Ala Wai Canal Project

Design Update for Ala Wai Canal Floodwalls

PREPARED FOR: U.S. Army Corps of Engineers, Honolulu District

DATE: June 16, 2016

PROFILE
ALA WAI CANAL MIDDLE (ALA2) AND LOWER (ALA1) LEFT BANK FLOODWALLS

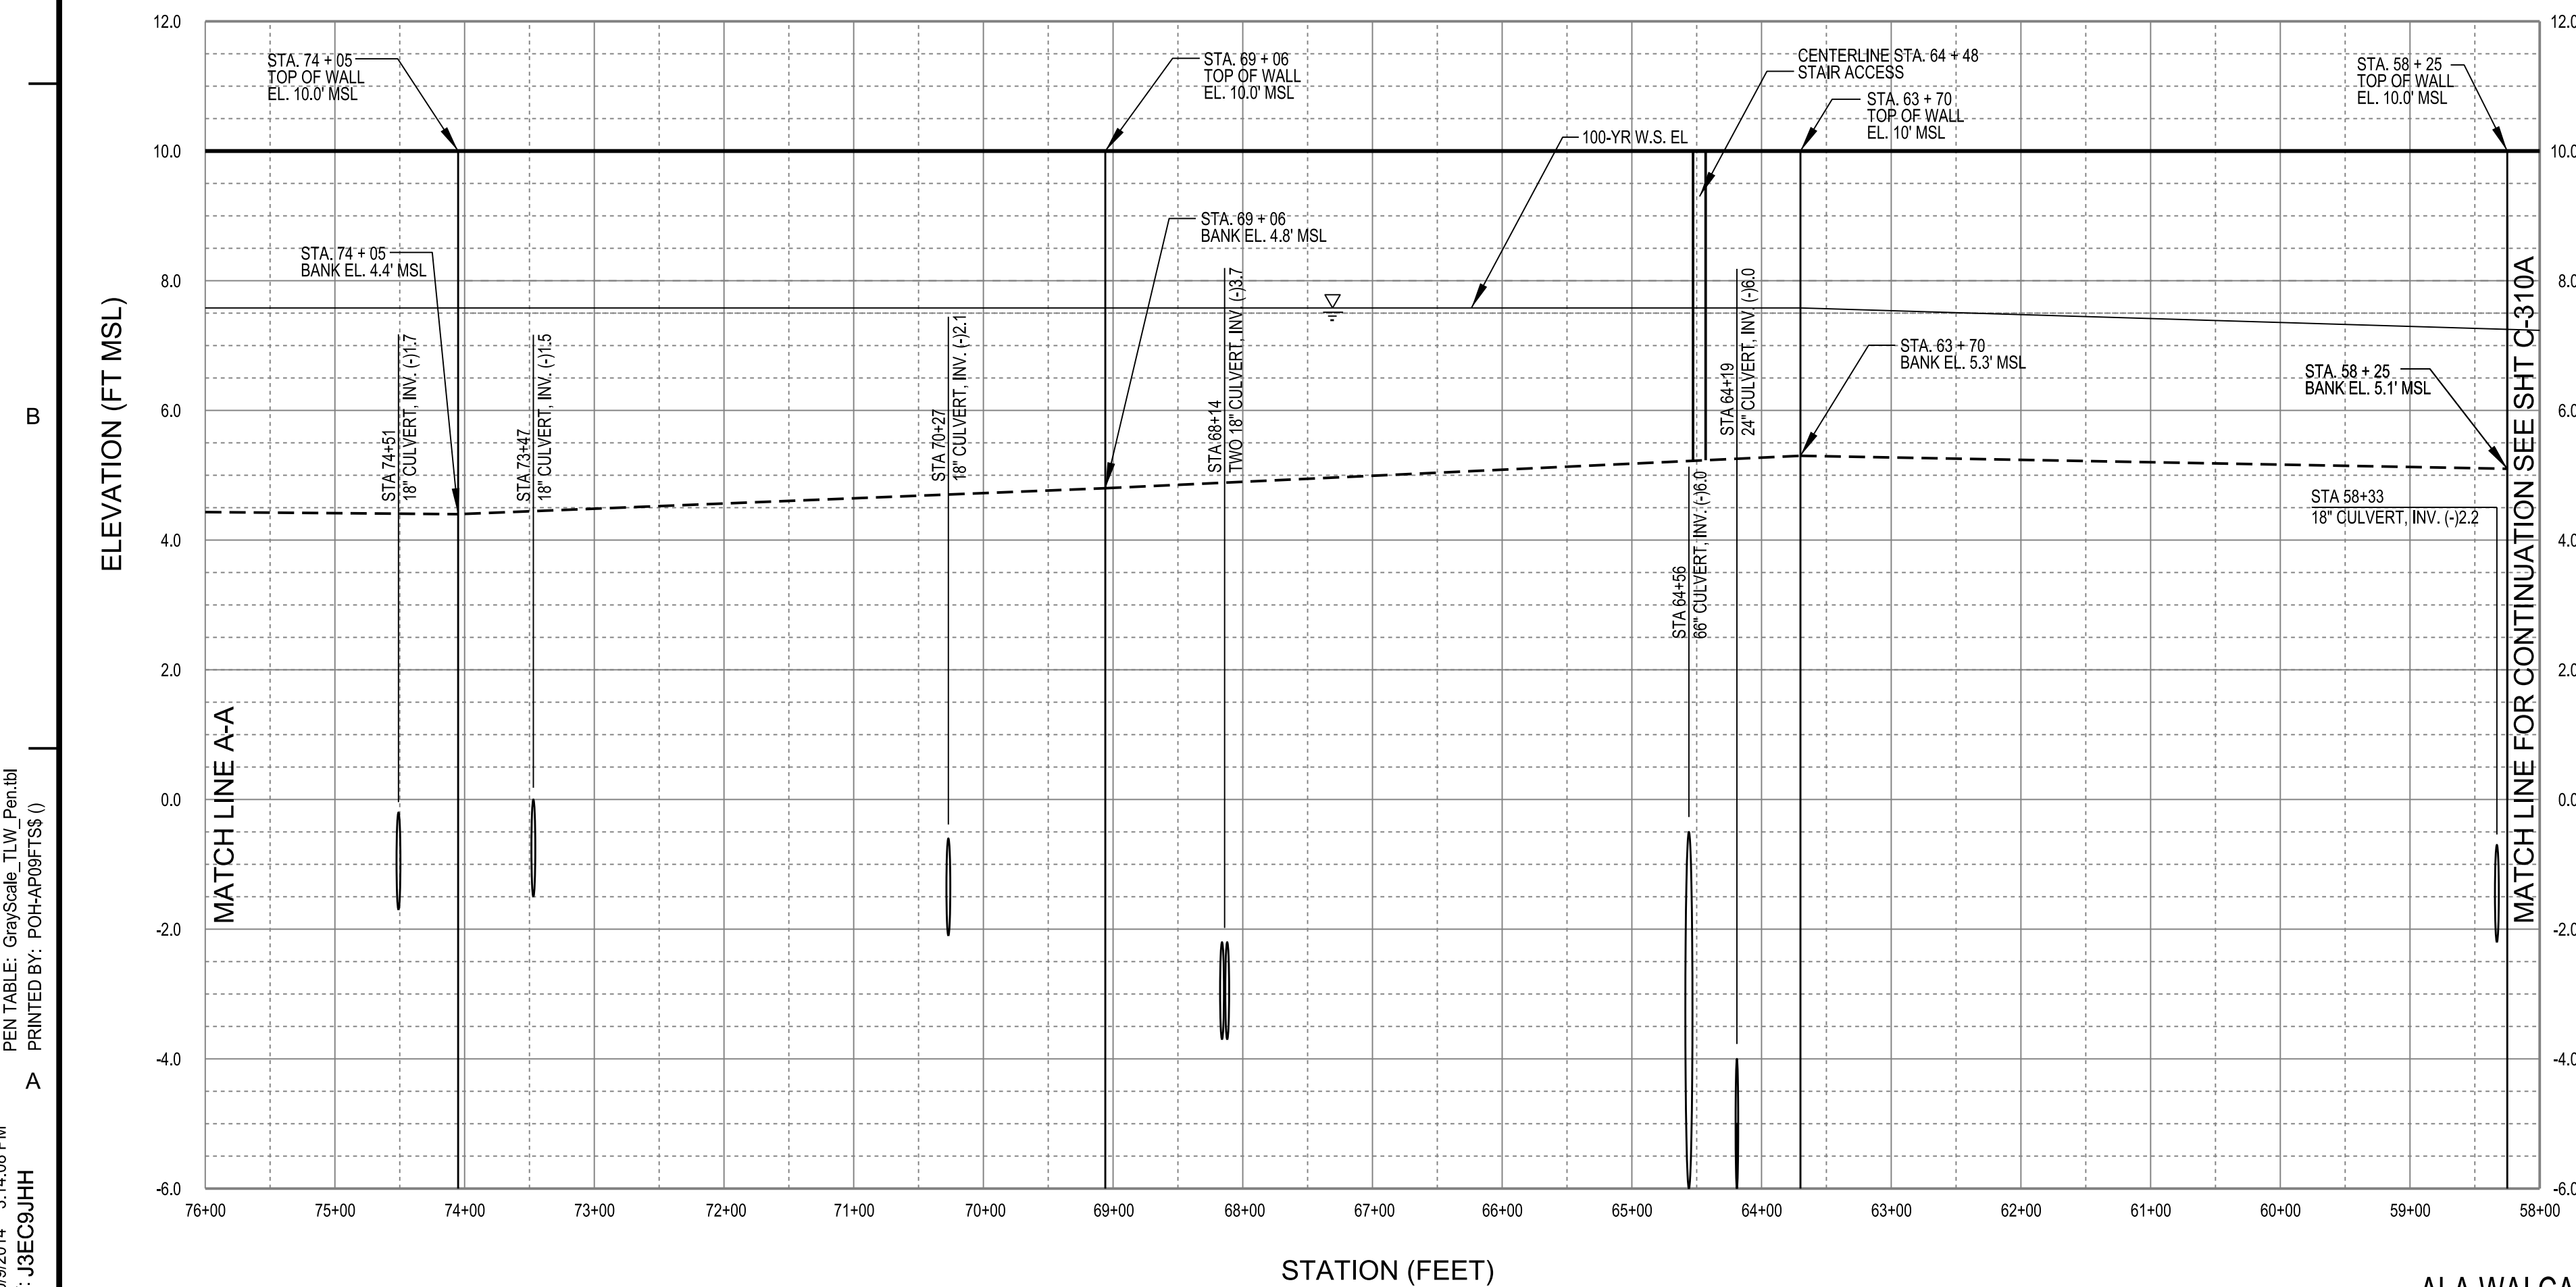
The "L" shaped left bank floodwall includes a foundation equal to only 2/3 the wall height, with all foundation in the toe and no foundation heel. Therefore, the Panel is concerned that the "L" shaped left bank floodwall foundations may not have sufficient factor of safety to resist sliding and overturning.

- The wall as shown on the 35% design drawings (Sheet C-310, Attachment 1) is inadequate to retain the maximum design flood.
- Based on inspection, the left bank wall section could be similar to the right bank floodwall section, if the loading and foundation conditions are very similar.

Ala Wai Canal FS/EIS Draft Report Appendix A2, Plate 11, TSP 35% Design sheets C-103, C-309 and C-316 indicate construction of “inverted T” shaped floodwalls for Hausten Ditch Detention Basin and the right bank (mountain side) Ala Wai Canal with foundations 3 feet below grade and 9.5 feet wide, with a key to resist sliding an additional 3 feet deep. Report Appendix A2, Plate 11, TSP 35% Design sheets C-310 and C-311 indicate construction of “L” shaped floodwalls for the left bank (ocean side) of the Ala Wai Canal with no foundation heel, no key, and the toe foundation 1 foot below grade.

In response to these findings, a wall section configuration similar to the right bank floodwall detail shown on Sheet C-309 was evaluated for the various loading requirements and wall heights. The required foundation size for the wall was adjusted to correspond to the specific wall heights for each reach of floodwall. The required floodwall dimensions for reaches along both the left and right banks are summarized in the tables on Sheet C-312 (Attachment 4).

C SECTION
SCALE: 3/8"=1'
FLOOD WALL OVER BOX CULVERT (TYP)

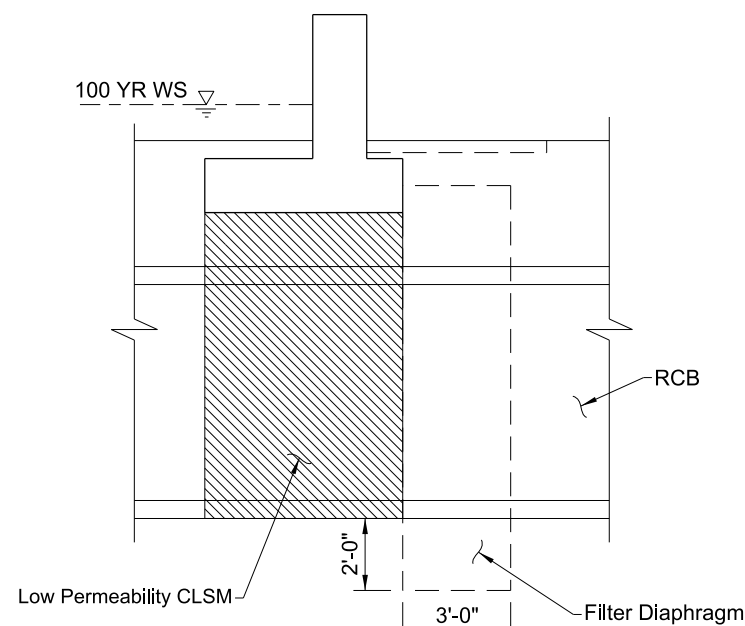
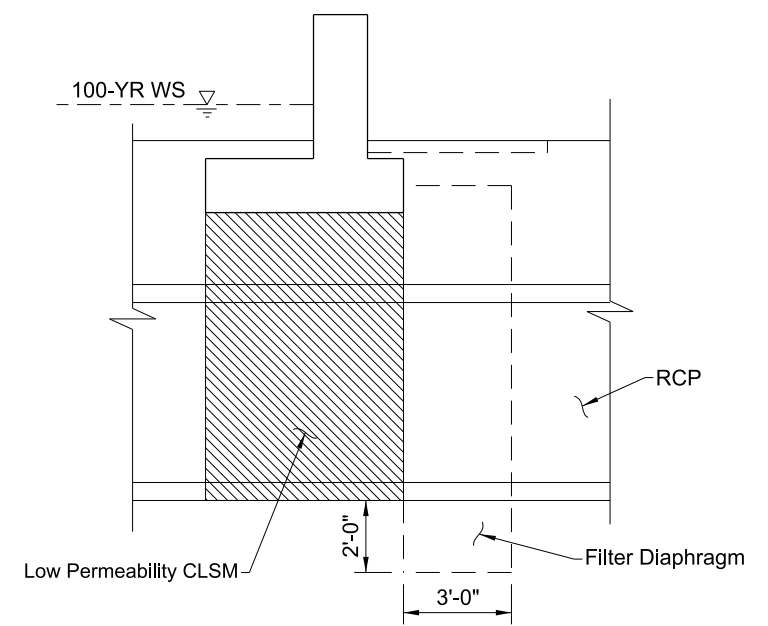
- Based on preliminary utility information, it is estimated that the proposed left bank floodwall would cross over approximately 49 storm drains at varying depths. Approximately 30 culverts on the left bank and 1 on the right bank would penetrate the proposed wall key below the footing. The invert elevation of approximately 13 culverts is unknown. At least two culverts would intersect the floodwall footings on both the left and right banks, and require the footing to be raised such that it would bridge over the culvert. Special structural details will be required where the wall crosses over these features. Full development of structural details for these crossings are beyond the current scope, but general concepts for construction requirements at typical culvert crossings are shown in Details C and D on Sheet C-312A (Attachment 4). Encasement with lean concrete or controlled low-strength material would be required to both limit under-seepage along the culvert and to transfer wall loads around the existing culverts. A filter diaphragm, consisting of sand material, should be installed at the downgradient side of the floodwall to limit the risk of internal erosion and piping.

1. Filter diaphragm consists of trench with imported sand to prevent piping at utility penetrations.
